FORD E4OD "UPDATE HANDBOOK"

*Updated
April, 2004*

VALVE BODY, SPACER PLATE, SPACER PLATE GASKETS, CHECKBALL LOCATIONS, AND CASE CHANGES, FOR THE 1996 MODEL YEAR

Figure 16

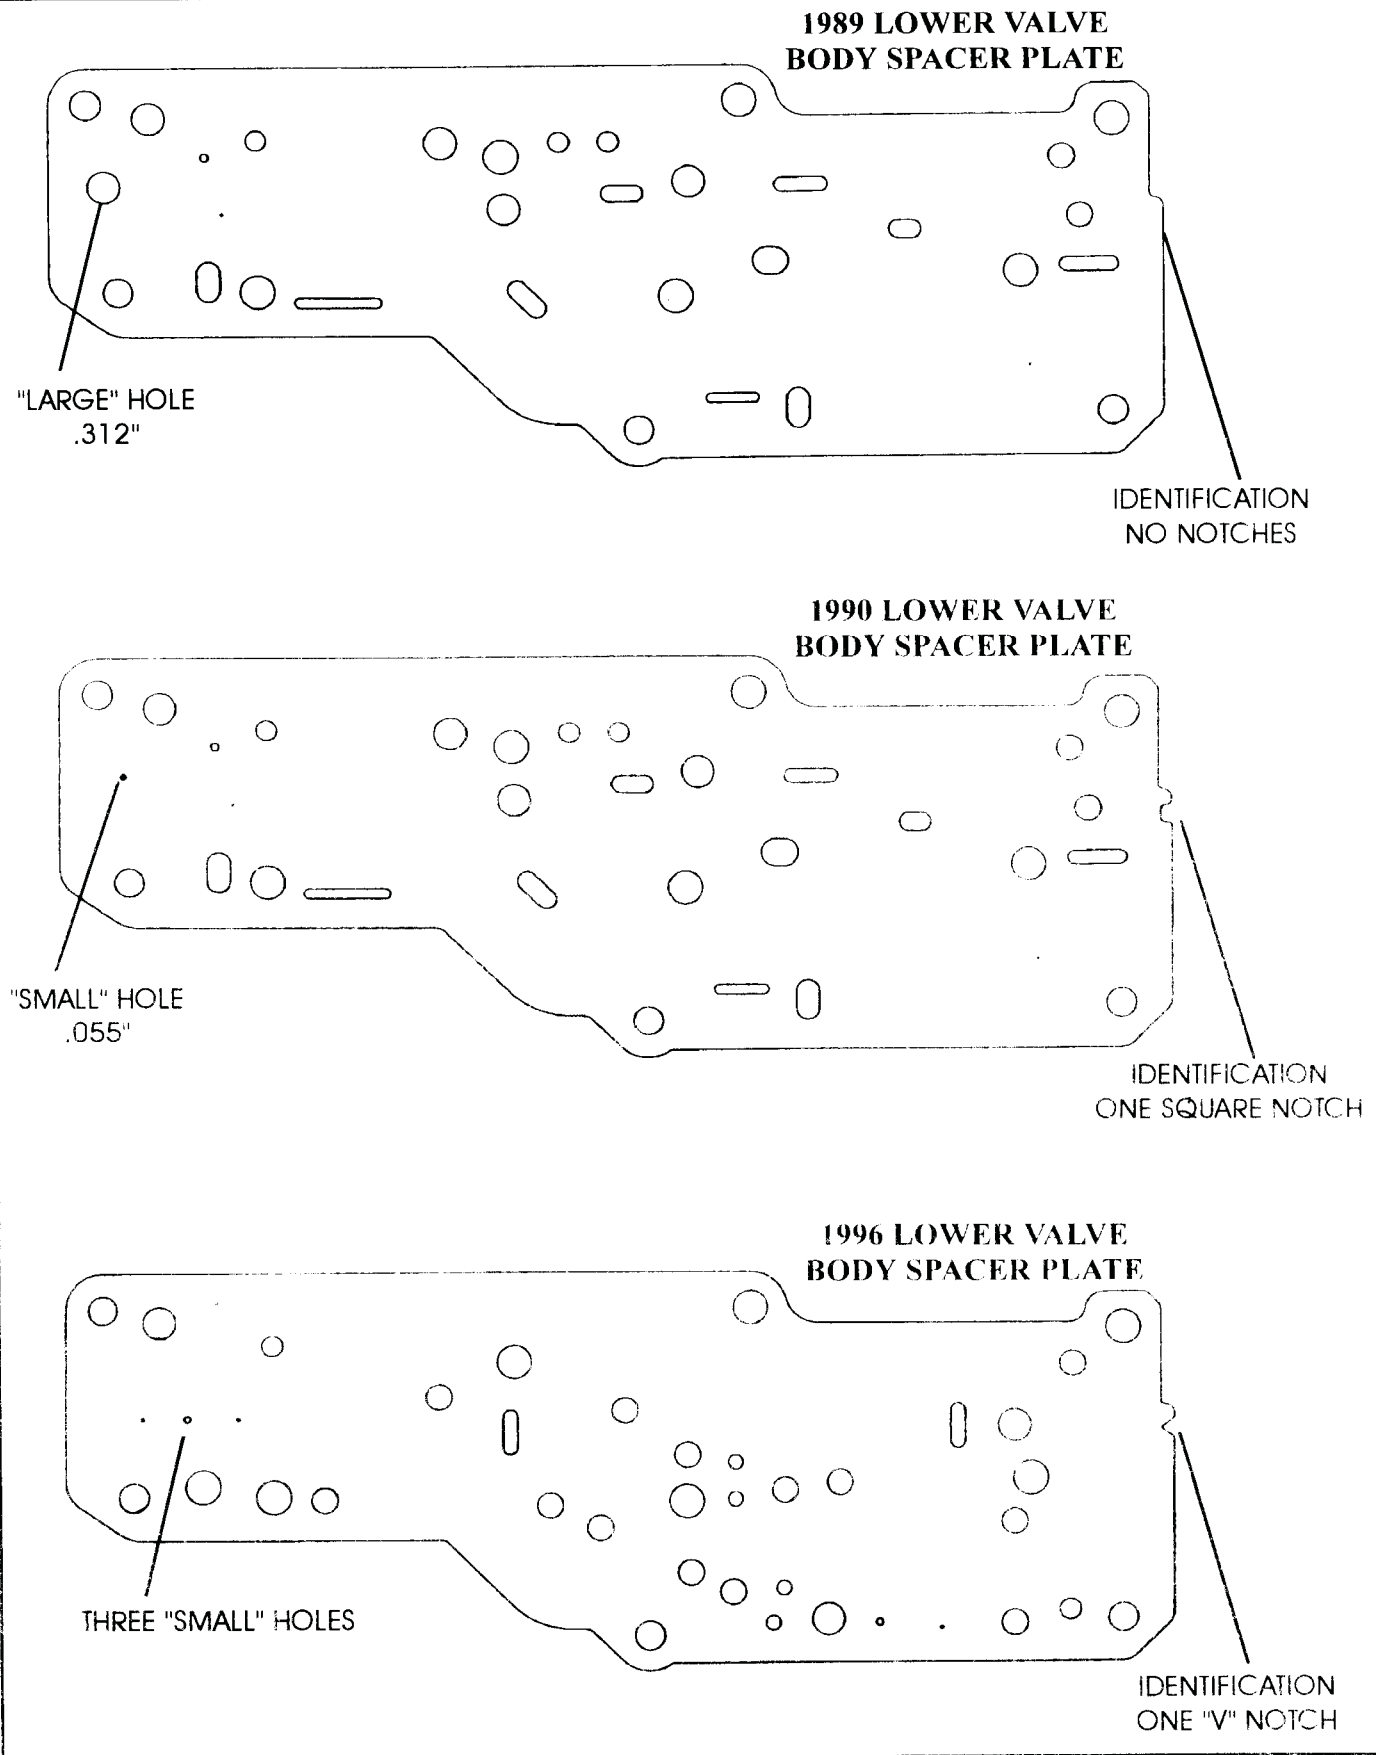
- (6) **LOWER VALVE BODY SPACER PLATE** - Can be identified by the diameter of the feed hole in the location shown in Figure 16. For 1989 models the hole diameter is .312", and for 90-95 models the hole diameter is .055".
The 1996-Up models have three small holes in this location, as shown in Figure 16, and a multitude of hole location differences to accommodate the added valve body checkballs.

Figure 24
AUTOMATIC TRANSMISSION SERVICE GROUP

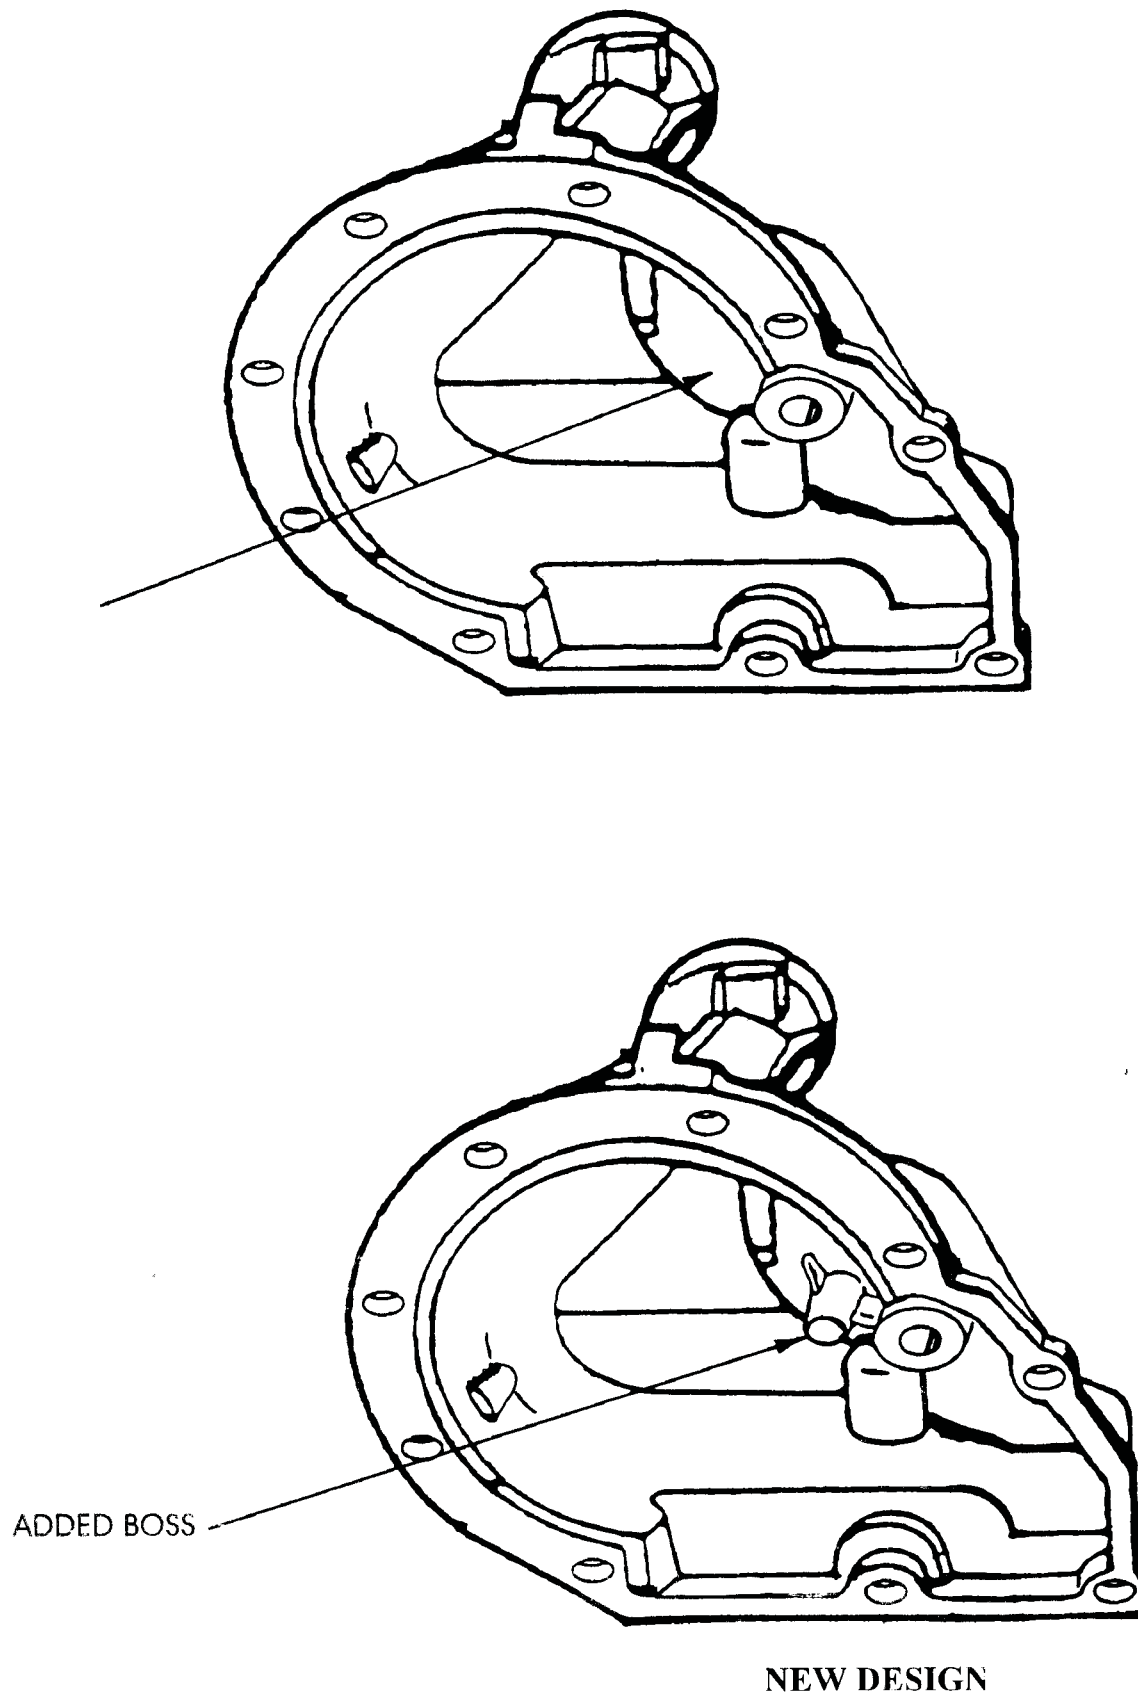
CORRECTION: There is now available a new service package, under OEM part number F0TZ-7A040-A, that includes a new design extension housing with a new "Boss" cast into it to prevent the parking gear from moving rearward in case the snap ring breaks (See Figure 24). The service package also includes a new "*high strength*" snap ring, and a snap ring installation aid, as shown in Figure 25.

Figure 27

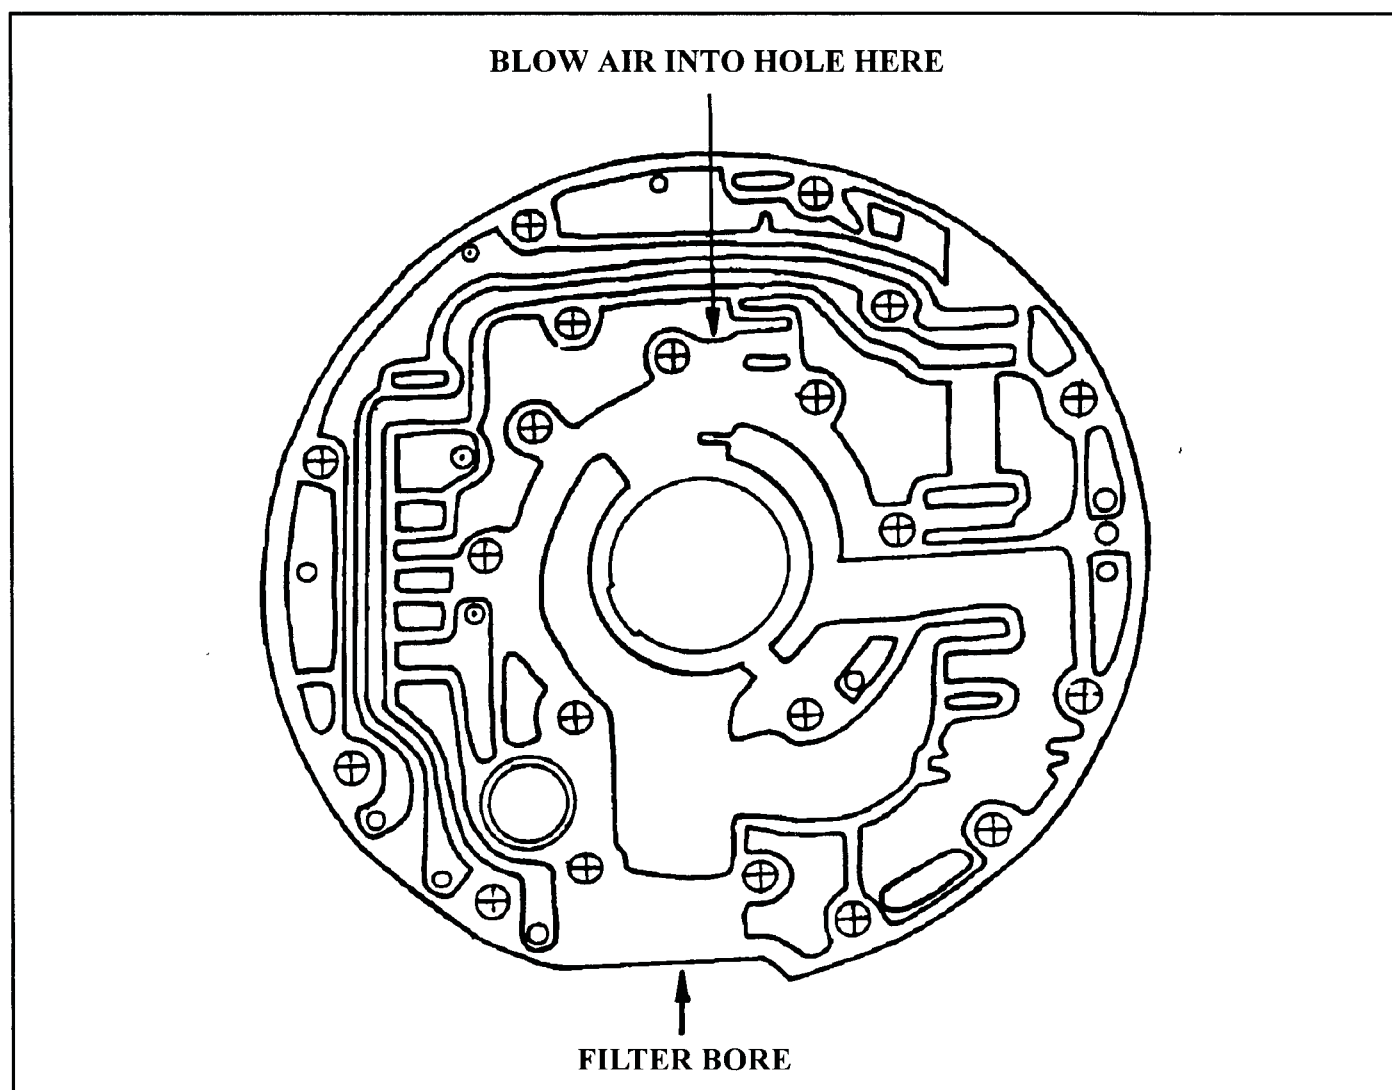
CORRECTION: To check for restriction, blow air into the hole in pump cover as shown in Figure 27, and air should exit from the holes in rear of stator shaft, as shown in Figure 28. If the passage is restricted or blocked the orificed cup plug must be removed, the plastic valve assembly replaced, and the passage thoroughly cleaned (See Figure 28)

Figure 29

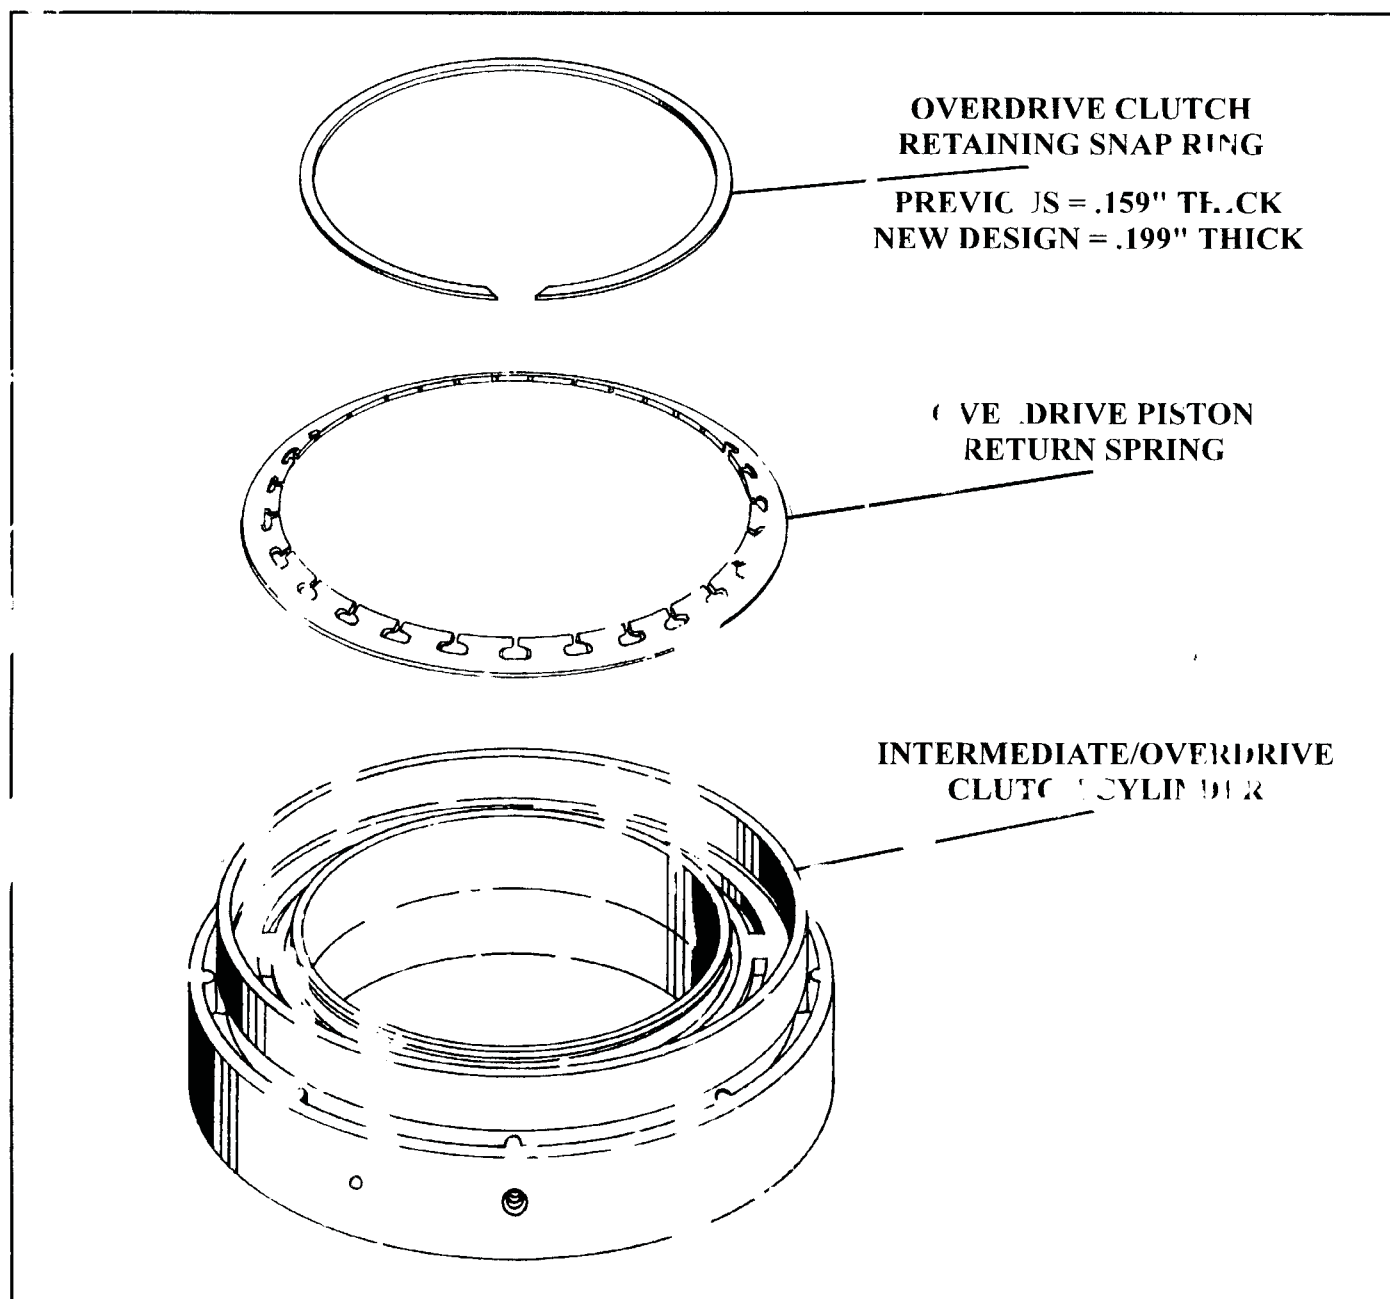
COMPLAINT: Harsh 3-4 shift, and/or, upon transmission disassembly the Overdrive Clutch retaining snap ring is dislodged from the groove (See Figure 29).

CAUSE: Insufficient tension on the Overdrive Clutch Snap Ring.

CORRECTION: Install a new design (Thicker) snap ring that has more tension than the previous design. The new design snap ring is .199" thick and the previous design is .159" thick, as shown in Figure 29.

Figure 30

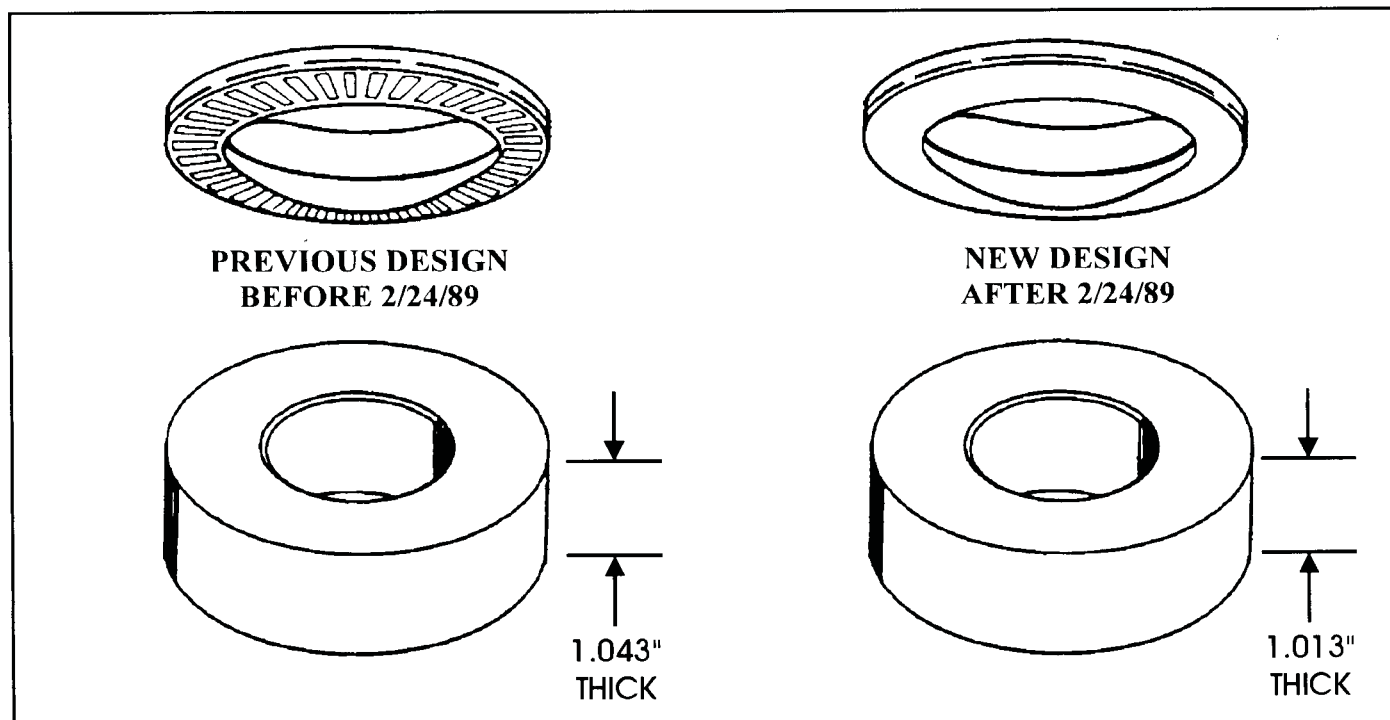
- (1) **LOW ROLLER CLUTCH INNER RACE** - As of 2/24/89, the Low Roller Clutch Inner Race height has been reduced by .030" to accommodate a revised hub to race thrust bearing. The previous inner race height was 1.043" and the new design is 1.013", as shown in Figure 30.
- (2) **HUB TO RACE THRUST BEARING** - The previous thrust bearing was a **2 Piece** (open face) design, and the new design is a **3 Piece** (closed) design bearing. The thickness of the previous 2 piece thrust bearing is .110" thick, and the new design 3 piece bearing is .140" thick, so that it is compatable with the new thinner inner race (See Figure 30).

Figure 33

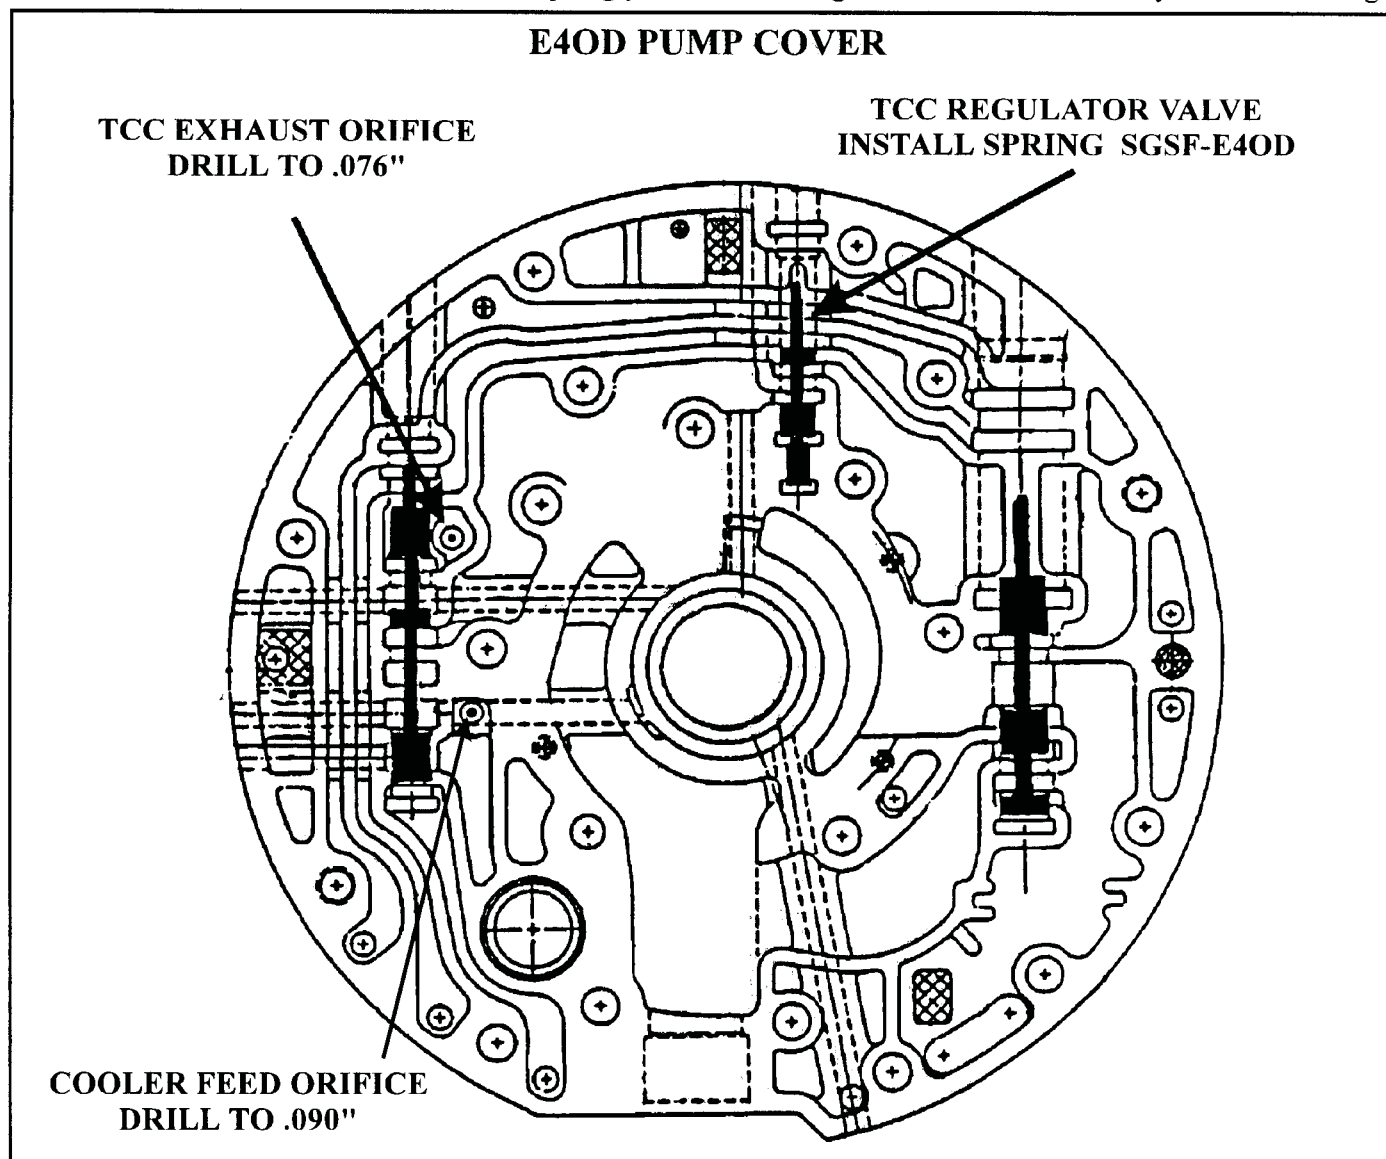
CORRECTION: Replace the converter clutch regulator valve spring, located in the pump cover with a "SGSF E4OD" shudder fix spring as shown in Figure 33. Also drill the converter clutch exhaust orifice out to .076", as shown in Figure 33.

It is also recommended to drill out the cooler orifice to .090" for increased lube flow, as shown in Figure 33.

NOTE: Ford Motor Company replaced this spring with a heavier spring in 1992 and later models, so ensure the spring you are installing is **heavier** than the one you are removing.
